Service Bulletin

S.B. No: 187

Title: INSPECTION FOR CLEARANCE BETWEEN RUDDER PEDAL AND MIXTURE/PROP. SPEED BRACKET. ALSO INCLUDES GENERAL RUDDER PEDAL CLEARANCES.

Applicability: T67M200 (Works No. 2264 & 2265 only), T67M260 and T67M260-T3A.

FIGURE 9

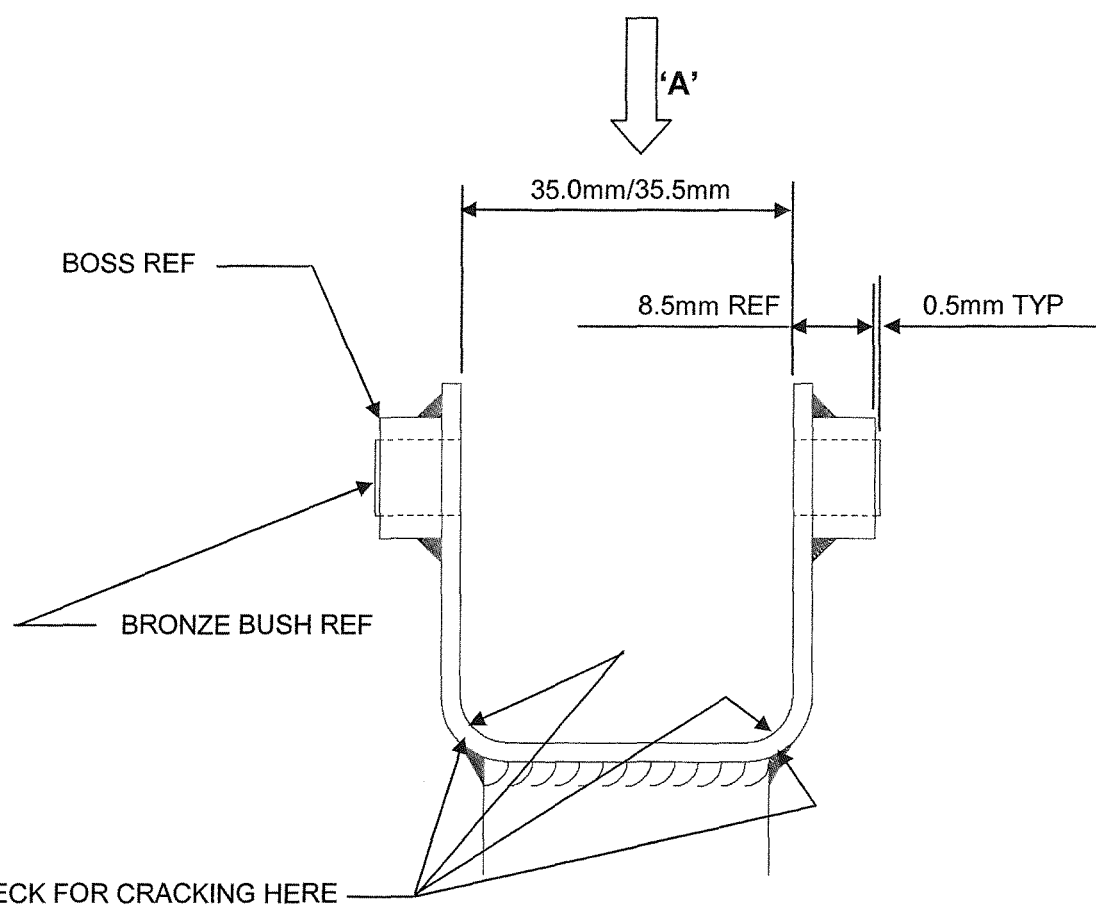
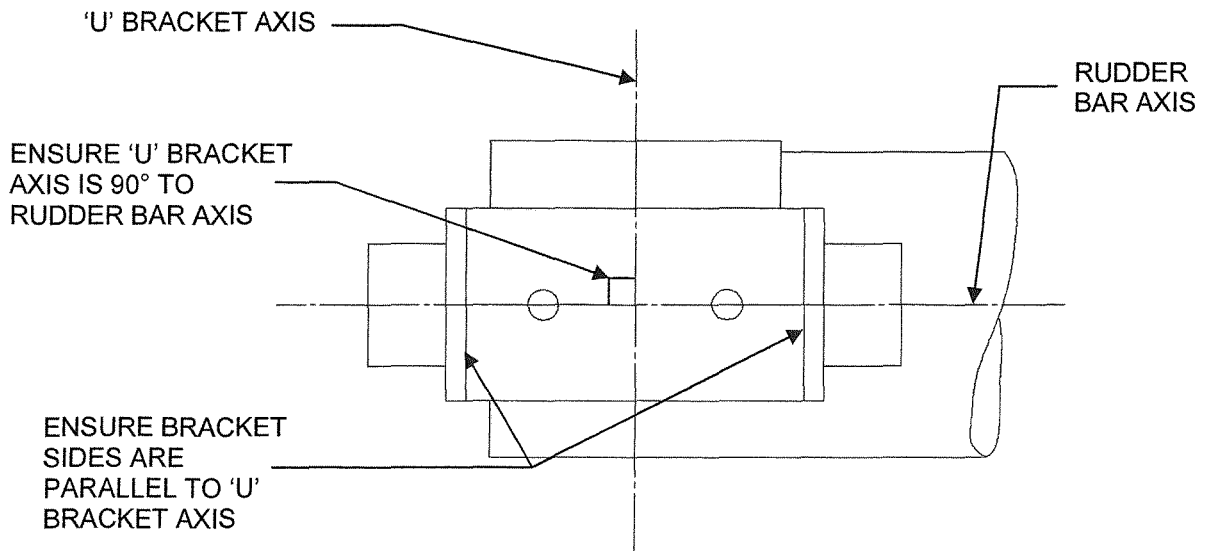
10. Ensure the rudder pedal carriages have full and free movement. If binding is suspected then check the 'U' bracket internal dimension. This should measure 35.0mm to 35.5mm, the bracket should also be parallel and square to the rudder bar axis, Figure 9 View on 'A' refers. Check that the pivot bush protrudes from its boss by 0.5mm. If the bracket internal dimension is greater or less, or if out of alignment then the bracket should be checked for cracking, refer Figure 9. If cracking is found then return rudder bar to SACL for rework. Finally check length of carriage pivot bolts, reference Figure 4, if binding is noted then replace bolts with bolt part number T67B-08-537 this introduces a bolt 15 mm long, measured from under head, and invokes Mod M808 "Introduction of Shortened Pivot Bolt to Rudder Pedal Slider Assembly Mounting". Also refer to SB130 Inspection of Rudder Pedals for Adjustment Restriction".

FIGURE 10

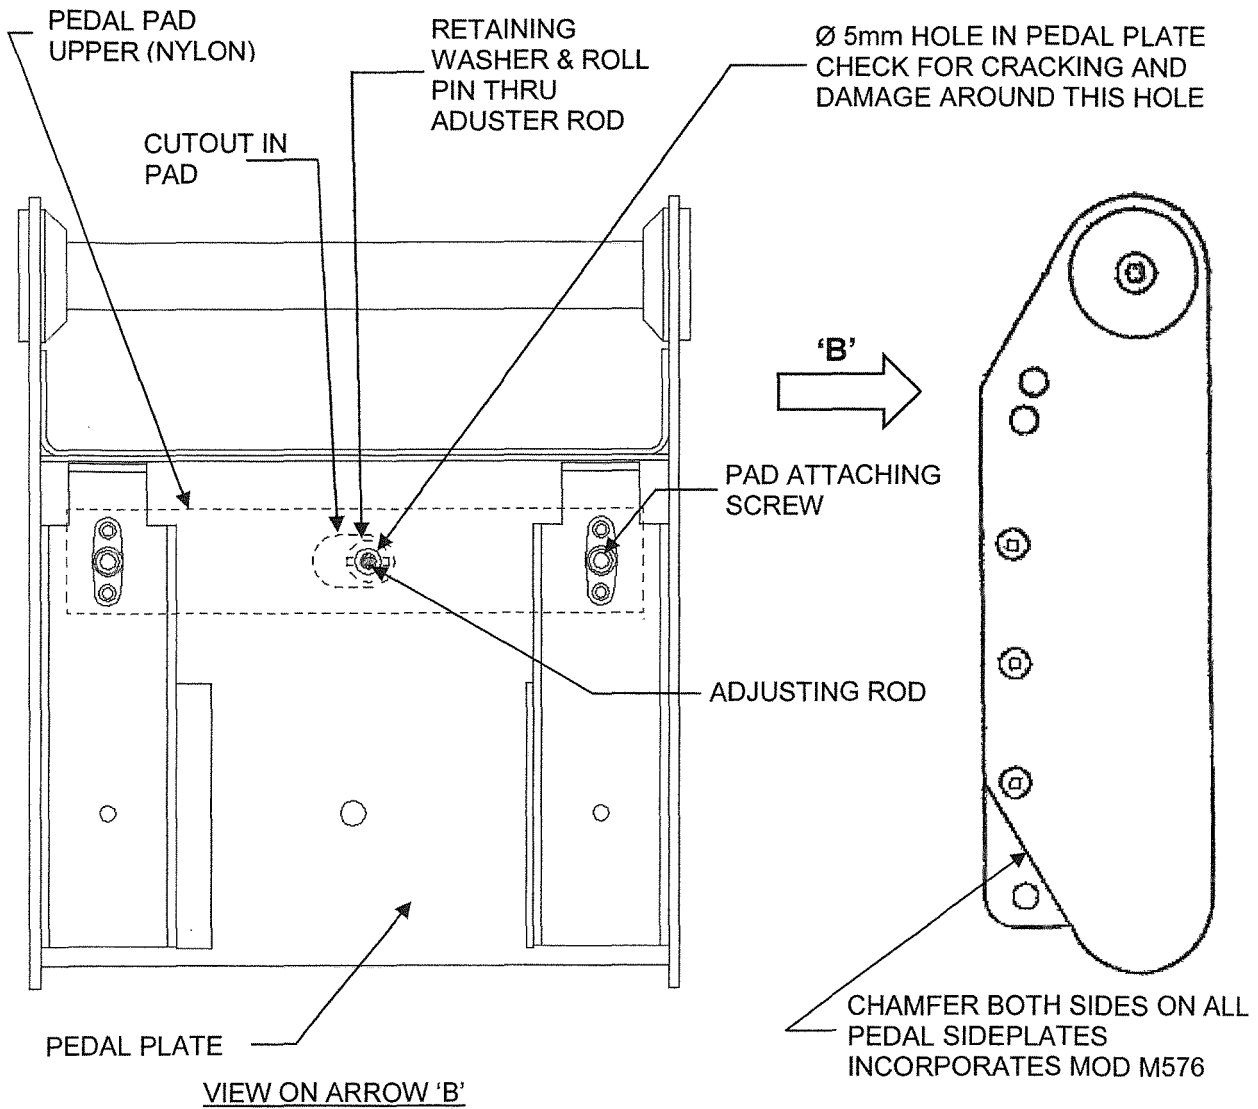
22. Ensure Mandatory Mod M576 has been invoked; AD 013-05-94 refers. Pedal side plate should be as Figure 10.
23. Check structural integrity of pedal pad assembly especially around adjuster pushrod hole pedal plate, Figure 10 View on Arrow 'B' refers, if plate is cracked or damaged the pedal pad is to be repaired. Ensure riveting is secure, if rivets are loose then they have to be rectified. Contact SACL for new pedal pad assembly, materials and any applicable repair scheme.
